# Access Compliance Report

## Public Rights-of-Way

### (Curb Ramps)

Intersection ID: 54321	Main Street: BELMONT_MANSION_DR	Cross Street: WRIGLEY_MANSION_DR	Location: W
ADA ID: D06D82BA9524	Ramp Type: BlendTrans1	Initial Pass/Fail: Fail	Overall Compliance: No
Severity Score: 1.25			
Codes/Mitigation Info/Possible Solution		Field Measurements/Component Compliance

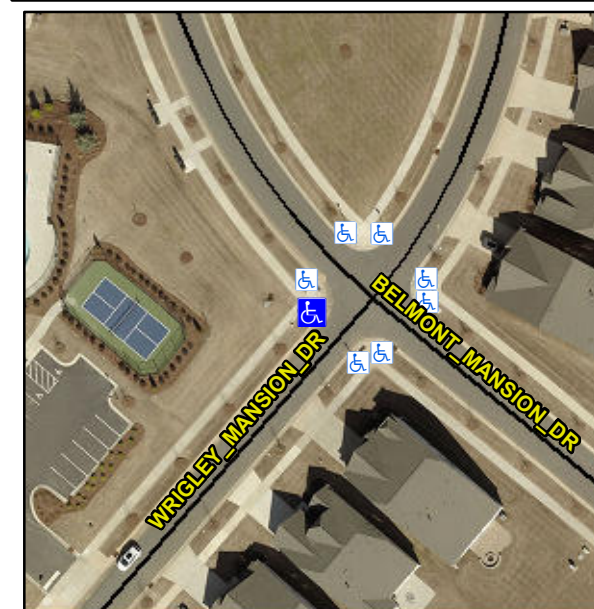
Compliance	Description	Data	Compliance	Description	Data
N/A	Ramp Length (in)	85.0	Yes	BlendTrans Slope (%)	4.0
Yes	Ramp Width (in)	48.0	No	BlendTrans XSlope (%)	4.8
N/A	Flare Type LT	N/A	N/A	Flare Type RT	N/A
N/A	Flare Slope LT (%)	N/A	N/A	Flare Slope RT (%)	N/A
N/A	Flare Traversable LT?	N/A	N/A	Flare Traversable RT?	N/A
N/A	Landing Length (in)	N/A	N/A	DWS Provided?	N/A
N/A	Landing Width (in)	N/A	N/A	DWS Contrast?	N/A
N/A	Landing Slope (%)	N/A	N/A	DWS Length (in)	N/A
N/A	Landing X Slope (%)	N/A	N/A	DWS Full Width?	N/A
N/A	Landing Curb? (Y/N)	N/A	N/A	DWS Offset (in)	N/A
N/A	Shared Landing?	N/A			
N/A	Gutter Ponding?	N/A	N/A	Gutter Slope (%)	N/A
N/A	Gutter Lip Ht (in)	1.0	N/A	Gutter X Slope (%)	N/A
N/A	Painted X Walk1?	No	N/A	Painted X Walk2?	N/A
	X Walk 1 Direction	To SE		X Walk 2 Direction	N/A
	X Walk 1 Width (in)	N/A		X Walk 2 Width (in)	N/A
	X Walk 1 Slope (%)	2.8		X Walk 2 Slope (%)	N/A
	X Walk 1 X Slope (%)	0.2		X Walk 2 X Slope (%)	N/A

**Remove & Replace Curb Ramp With Two New Directional Ramps or Equivalent.**
